MAJOR Amendment Notice 2

Licence Number L4459/1987/13

Premises Argyle Diamond Mine
Mineral Lease 259SA, L80/11, L80/24, L80/31,
M80/114
Lissadell Road
ARGYLE WA 6743

Date of amendment 9 June 2017

ATTACHMENT 6: NEW LANDFILL LOCATION SHOWN IN GREEN

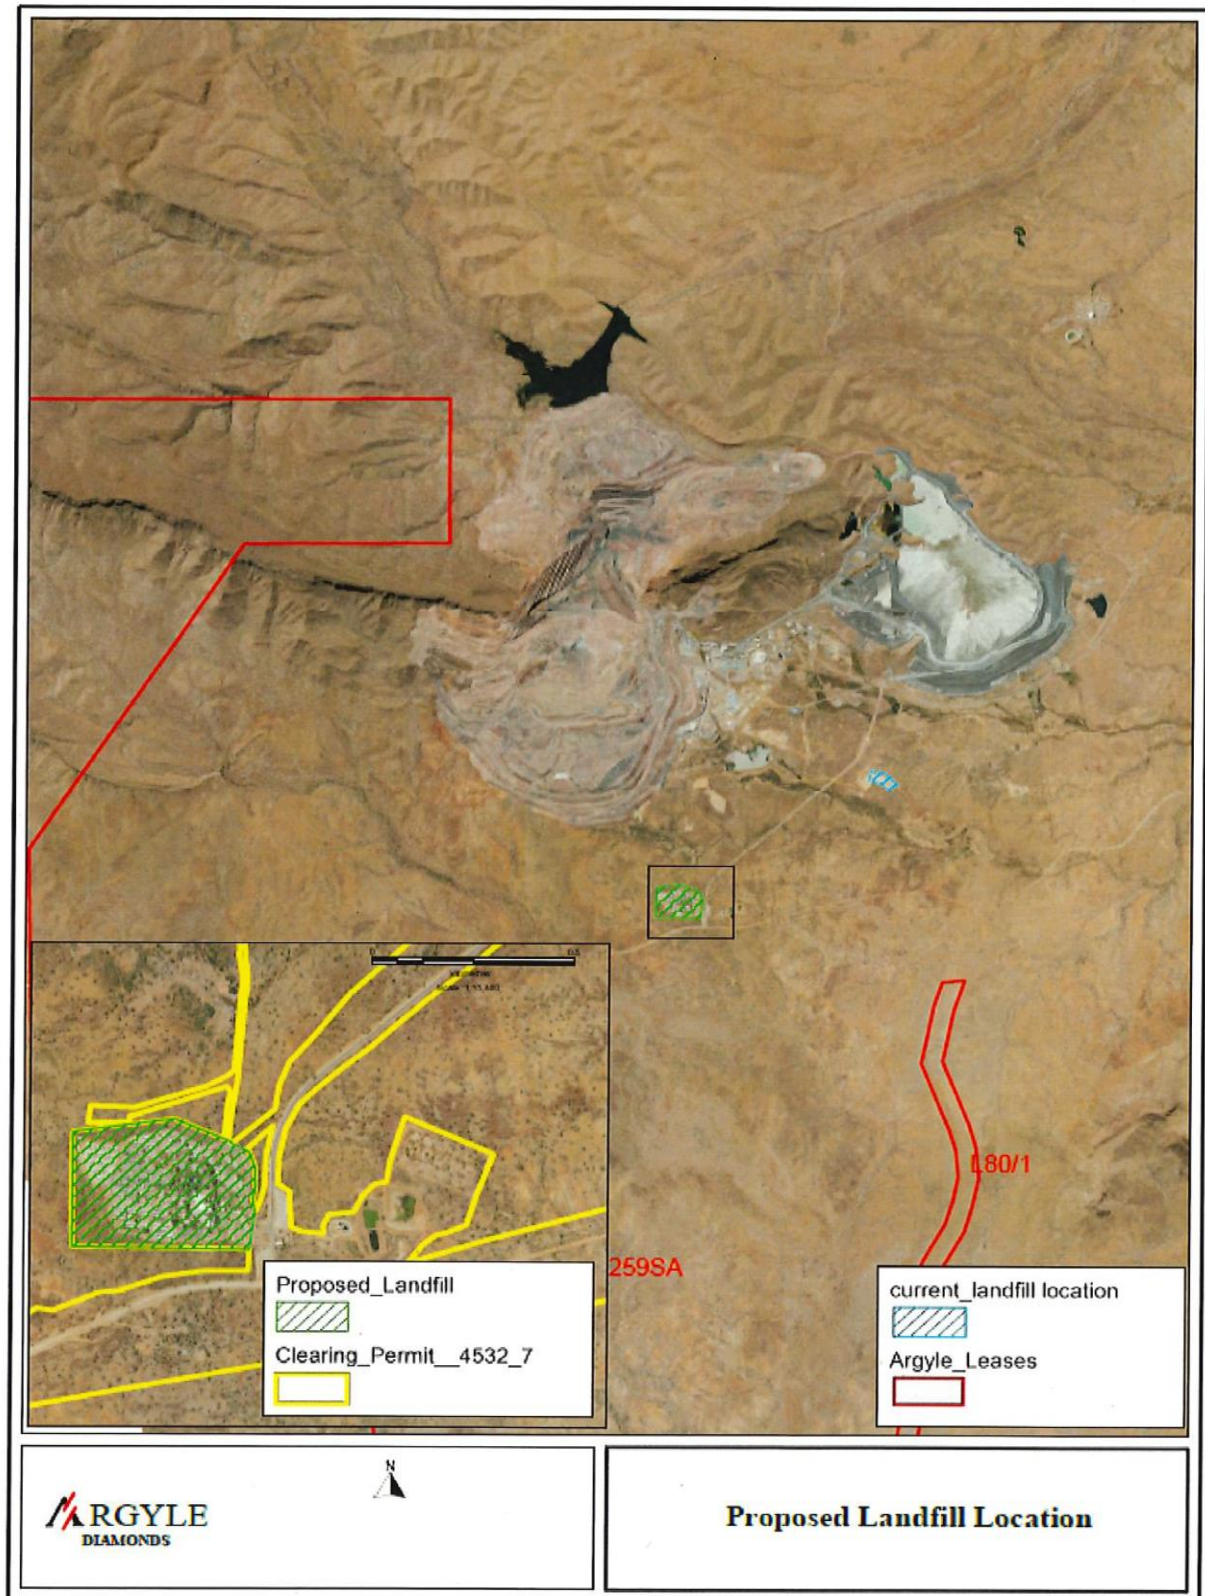
9. A new map in Attachment 6 has been included that shows the location of the new landfill.
